Product/Process Change Notice (PCN)

PCN Number: PCN_WL-SUMW_20250201 Affected Series: WL-SUMW Affected Part Number: 15335327CA452, 15335327CA554 PCN Date: 2024-11-01 (YYYY-MM-DD) Effective Date: 2025-02-01 (YYYY-MM-DD)	Change Category: ☒ Equipment/Location ☐ General Data ☒ Material ☐ Process ☒ Product Design ☒ Shipping/Packaging ☒ Supplier ☐ Software															
Contact: Product Management Phone: +49 (0) 7942 - 945 5001 Fax: +49 (0) 7942 - 945 5179 E-Mail: pcn.eisos@we-online.com	Datasheet Change: ☒ Yes ☐ No Attachment: ☐ Yes ☒ No															
DESCRIPTION OF CHANGE: In line with internal standardisation, Würth Elektronik eiSos will update the product package. There will be no change in function, quality or reliability of the product. All products with date code 2024-11-01 or later, will be affected by this change. After the effective date, only the new revision of the affected order codes will be sent out.																
Details of Change:

Product dimension change:

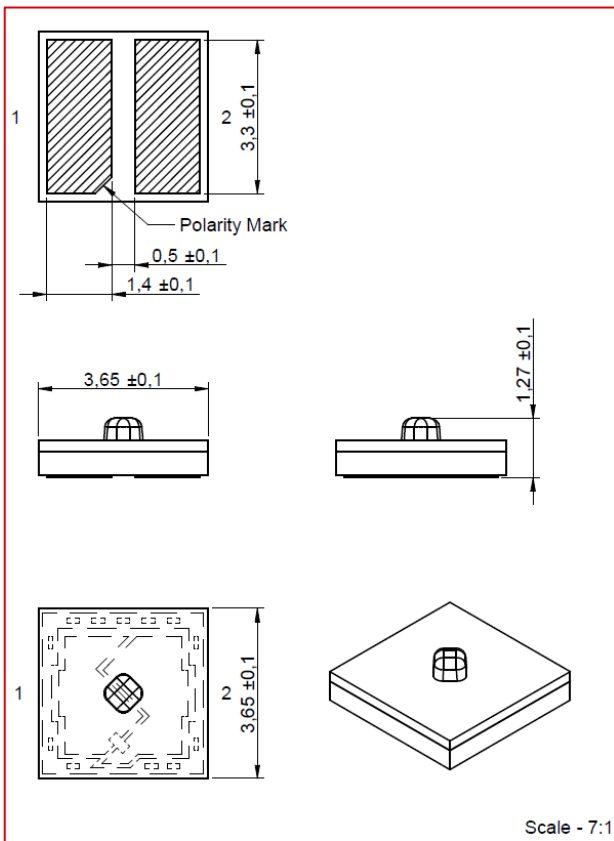
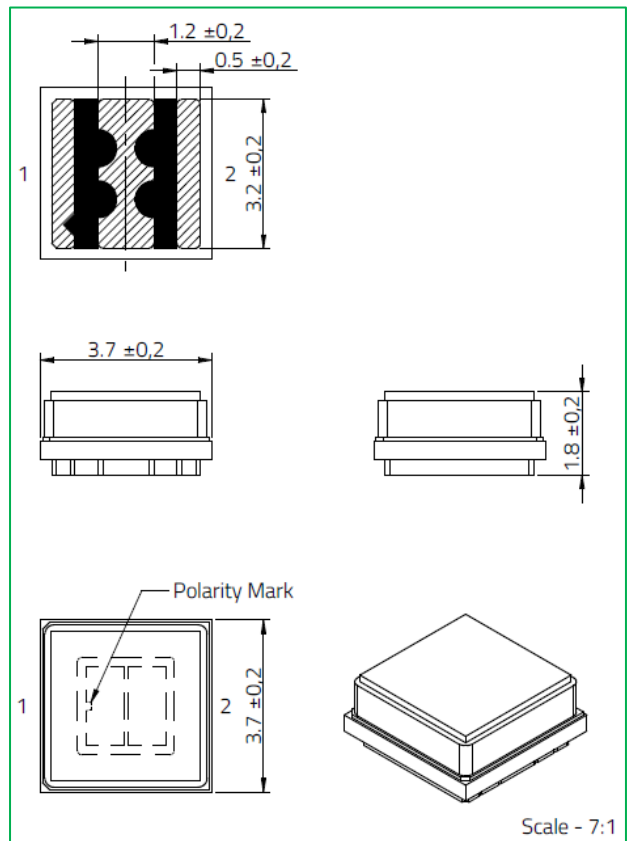
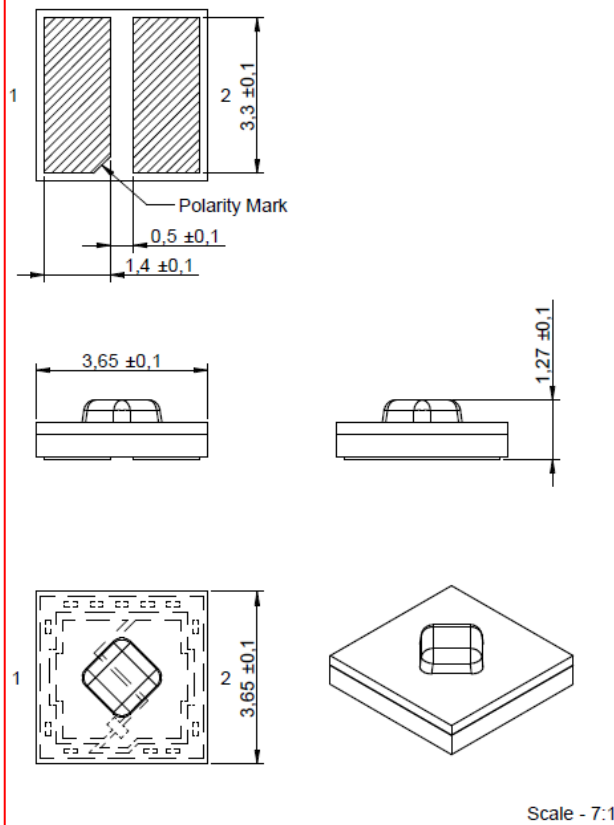
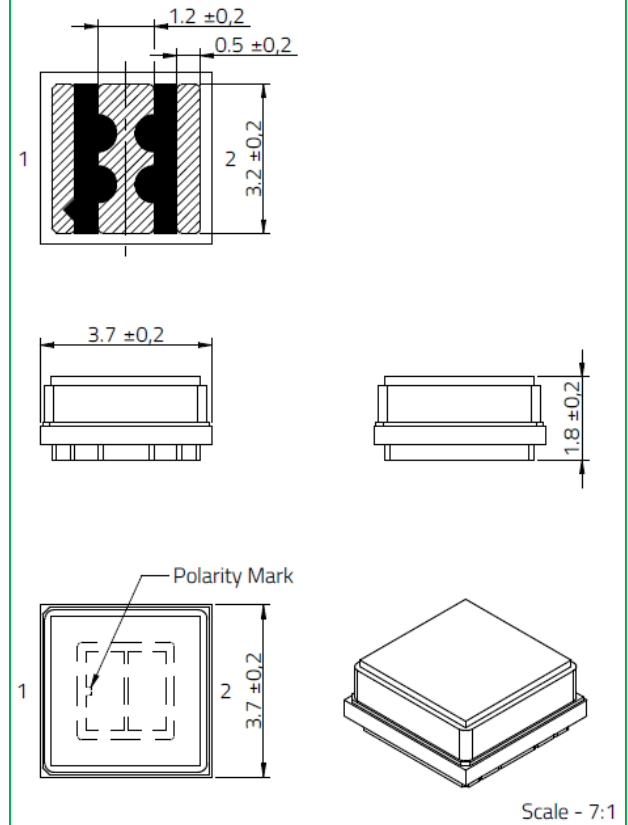
<table><tr> <th></th> <th>Before Change</th> <th>After Change</th> </tr><tr> <td>Product details</td> <td>3.65x3.65x1.27 mm, 2 pads</td> <td>3.7x3.7x1.8 mm, 3 pads</td> </tr><tr> <td>Viewing angle:</td> <td>15335327CA452: 140° 15335327CA554: 150°</td> <td>120°</td> </tr></table>

Packaging drawing change:

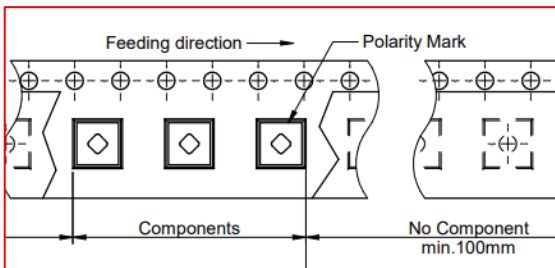
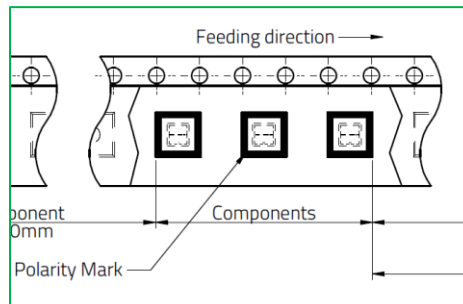
<table><tr> <th></th> <th>Before Change</th> <th>After Change</th> </tr><tr> <td>Packaging Quantity:</td> <td>15335327CA452: 500 pcs 15335327CA554: 250 pcs</td> <td>1000 pcs</td> </tr></table>
